Memorandum

FROM: Israel Roberts, AICP
Planning Manager

SUBJECT: PRELIMINARY PLAT FOR TWIN OAKS ADDITION

PRELIMINARY PLAT
TWIN OAKS
LOTS 1-10, BLOCK A
16.81 GROSS ACRES
2.30 ACRES R.O.W.
14.51 ACRES NET OUT OF THE
SAMUEL SLOAN SURVEY ABST. 791,
TOWN OF FAIRVIEW
COLLIN COUNTY, TEXAS
EX. ZONING: PC (Planned Center District)

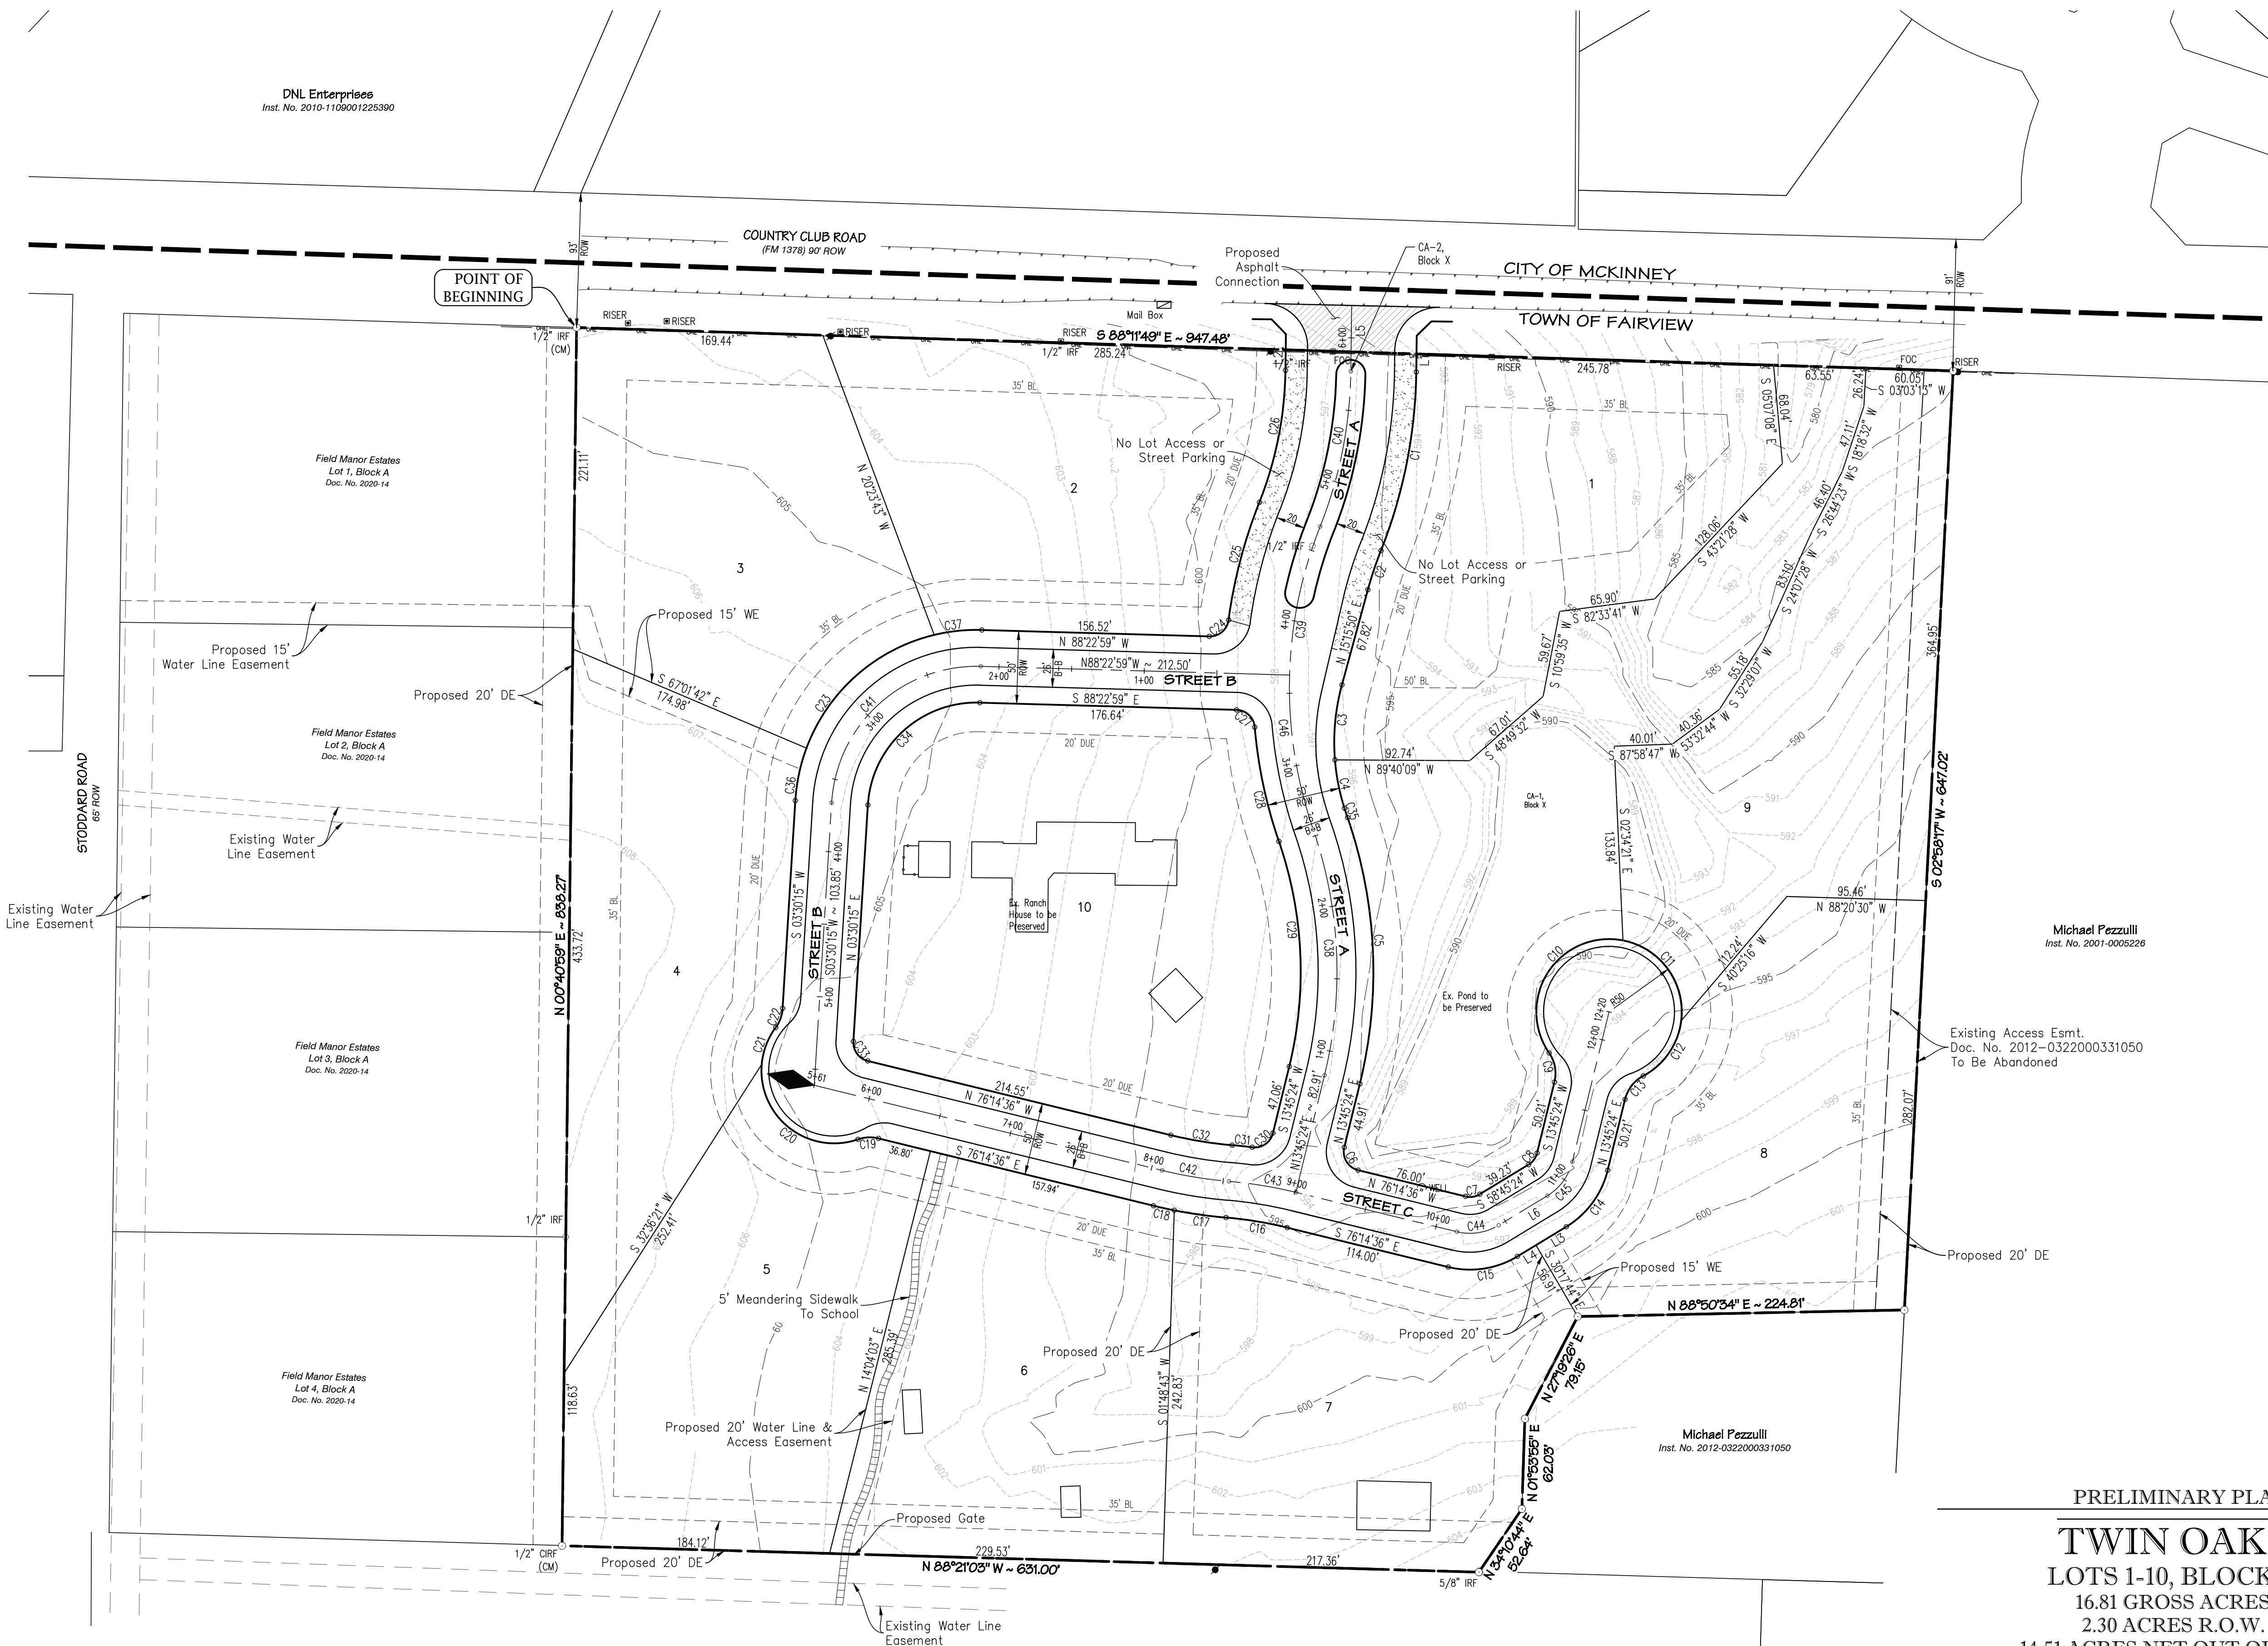
This (PC) Planned Center District requires that each residential lot maintain a minimum of 1.2-acres in area. Additionally, in accordance with the (RE-1.5) standards, each residential lot must have a minimum lot width, as measured at the front building line, of 150 feet. Lots with frontage on a cul-de-sac are permitted a reduced lot width of 70 feet (Lot 9). All lots meet these design standards.

STAFF RECOMMENDATION: Staff recommends **APPROVAL** of the proposed preliminary plat as presented.

PRELIMINARY DRAINAGE PLAN

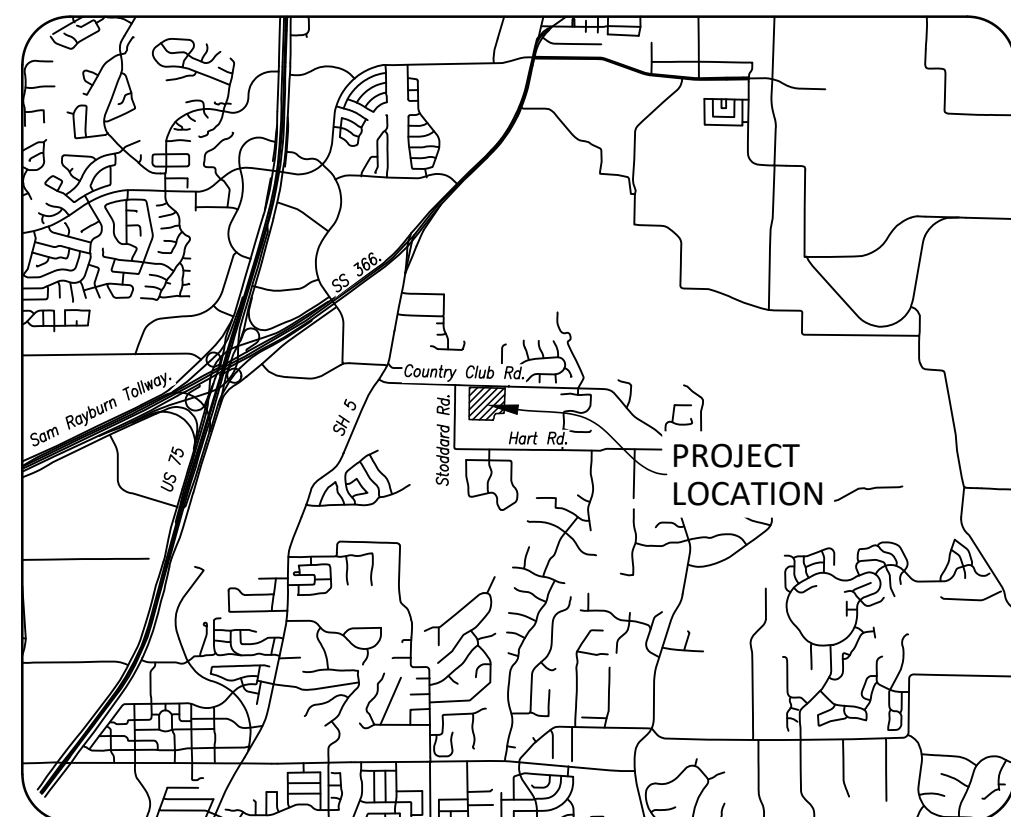
The preliminary drainage plan submitted for Twin Oaks is sufficient at this stage of the development process. They do not show any lot-to-lot drainage being required, they are planning on continuing to receive and prepare for off-site water that sheet flows onto the site, and their discharge point from the subdivision is located at a TxDOT culvert under FM1378. The impact of drainage increases with development will be felt at the culvert under FM1378 and then downstream into the Serenity Subdivision in the City of McKinney. When full civil plans are submitted to the town, we will coordinate with TxDOT and the City of McKinney in regard to drainage increases and acceptable flows. If either TxDOT or McKinney do require any detention on the Fairview side, we will communicate that to the developer and the existing pond could easily be converted into a stormwater detention pond if needed at that time during the final civil review.
